Access Compliance Report

(Curb Ramps)

Intersection ID: 12052	Main Street: E_17TH_ST	Cross Street: PEGRAM_ST	Location: W
ADA ID: D9B30C700147	Ramp Type: PerpDiag	Initial Pass/Fail: Fail	Overall Compliance: No
Severity Score: 35			
Codes/Mitigation Info/Possible Solution		Field Measurements/Component Compliance

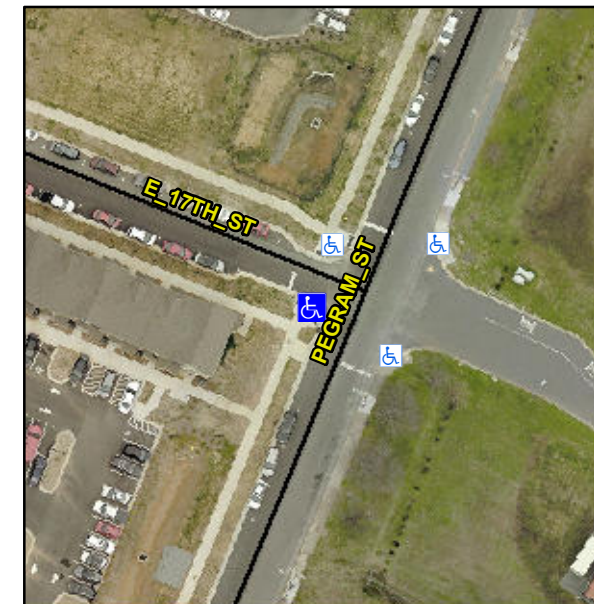
Not Found, R304.5.1

Compliance	Description	Data	Compliance	Description	Data
N/A	Ramp Length (in)	68.0	Yes	Ramp Slope (%)	6.6
No	Ramp Width (in)	24.0	Yes	Ramp XSlope (%)	0.2
N/A	Flare Type LT	N/A	N/A	Flare Type RT	N/A
N/A	Flare Slope LT (%)	N/A	N/A	Flare Slope RT (%)	N/A
N/A	Flare Traversable LT?	N/A	N/A	Flare Traversable RT?	N/A
N/A	Landing Length (in)	N/A	N/A	DWS Provided?	N/A
N/A	Landing Width (in)	N/A	N/A	DWS Contrast?	N/A
N/A	Landing Slope (%)	N/A	N/A	DWS Length (in)	N/A
N/A	Landing X Slope (%)	N/A	N/A	DWS Full Width?	N/A
N/A	Landing Curb? (Y/N)	N/A	N/A	DWS Offset (in)	N/A
N/A	Shared Landing?	N/A			
N/A	Gutter Ponding?	N/A	N/A	Gutter Slope (%)	N/A
N/A	Gutter Lip Ht (in)	N/A	N/A	Gutter X Slope (%)	N/A
N/A	Painted X Walk1?	No	N/A	Painted X Walk2?	No
	X Walk 1 Direction	To SE		X Walk 2 Direction	To NE
N/A	X Walk 1 Width (in)	N/A	N/A	X Walk 2 Width (in)	N/A
	X Walk 1 Slope (%)	4.6		X Walk 2 Slope (%)	2.1
	X Walk 1 X Slope (%)	2.3		X Walk 2 X Slope (%)	1.7

Remove & Replace Curb Ramp With Two New Directional Ramps or Equivalent.
